Form 3160-3 (June 2015)						APPRON	137	
UNITED STAT	Expires. Ja	inuary 51	, 2018					
DEPARTMENT OF THE			_		5. Lease Serial No.	5. Lease Serial No. NMNM102034		
BUREAU OF LAND MAN								
APPLICATION FOR PERMIT TO	6. If Indian, Allotee	or Tribe	Name					
1a. Type of work: ✓ DRILL	7. If Unit or CA Agr	reement,	Name and No.					
1b. Type of Well: Vil Well Gas Well								
1c. Type of Completion: Hydraulic Fracturing	8. Lease Name and Well No. STARK 33 FED COM

2. Name of Operator EOG RESOURCES INCORPORATED					771H 9. API Well No. 30-	-015-	56634	
3a. Address 1111 BAGBY SKY LOBBY 2, HOUSTON, TX 77002	e)	10. Field and Pool, of PURPLE SAGE; W

OPERATOR'S NAME:	EOG RESOURCES INCORPORATED
WELL NAME & NO.:	STARK 33 FED COM 771H
SURFACE HOLE FOOTAGE:	520'/S & 889'/W
BOTTOM HOLE FOOTAGE	230'/S & 337'/W
LOCATION:	Section 33, T.25 S., R.30 E., NMP
COUNTY:	Eddy County, New Mexico

520' FSL 889' FWL Section 33 T-25-S, R-30-E Proposed Wellbore Design B KB: 3,203' GL: 3,178'

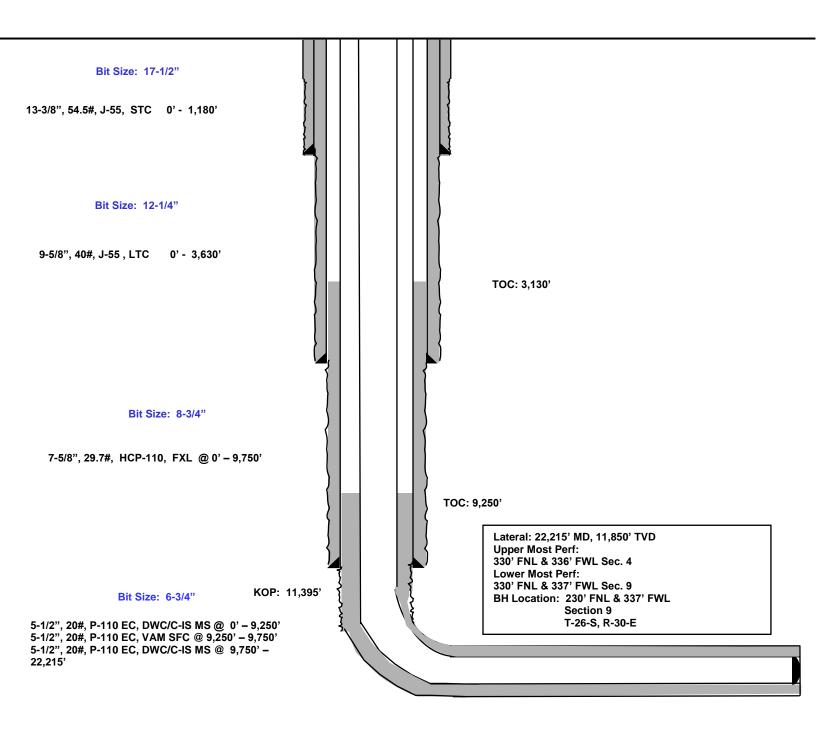
Operator is only approved for Design A. Design B is not to be utilized. If Design B is needed or any other change, please submit a NOI sundry to make the changes.
